# **Staff Report**

**Date**: April 2, 2015

Subject: Hardie, After-the-Fact Variance and Project Modifications, 128 Winding Way, File

1919

412 Pen Plant Pen Amerika. ES 25 260 100 200 200 200 08/06/13 8 g Associates SITEWORK
SITEWORK MENDA BOZYKD SITE PLAN NOTES (1) 20 A121 SITE PLAN

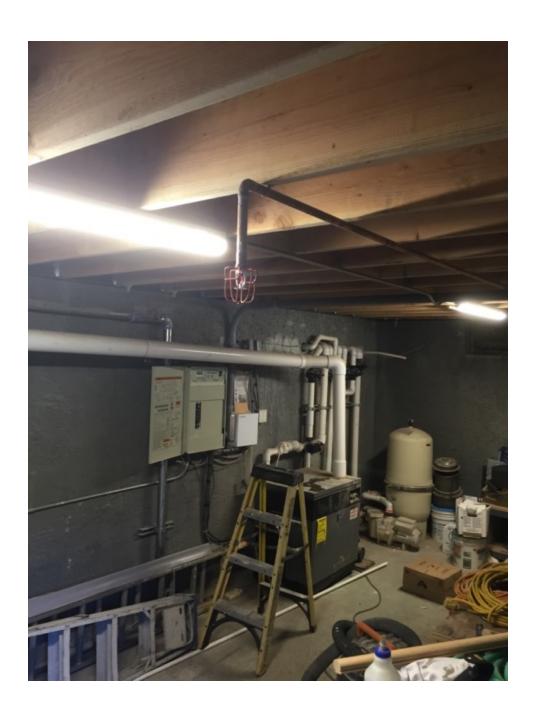
That is what it is supposed to be - but not what I saw on the plans. That us why I wanted you to check to see if I am reading the civil plans incorrectly. I don't think that is the only tall area of wall when I checked the top of wall and bottom of wall/finished grade for those other areas I noted.

Planning would like to have confirmation that none of the walls exceed 6ft in height.

Cc: Simone Jamotte; Rob Braulik; Elise Semonian **Subject:** Re: Hardie Residence - 128 Winding Way Can you confirm I am reading the plans correctly and that there are new walls over 6 feet tall on the civil plans in more than one area? Near the garage, near the driveway stairs, the tallest part of the driveway walls? The only one I didn't have concern with is the "planter" /wall for the new entry stair, which is sort of part of the residence. It is just a planning department issue - but they would need council approval of variances for those areas.

RESPONSE: All retaining walls do not exceed 6 ft in height. The only site wall over 6 ft. tall is the curving sound wall on the north side of the swimming pool deck in response to a neighbor's request to mitigate noise from the pool area. The sound wall in the Sitework Permit Submittal has not changed since it was approved by the Town Council.
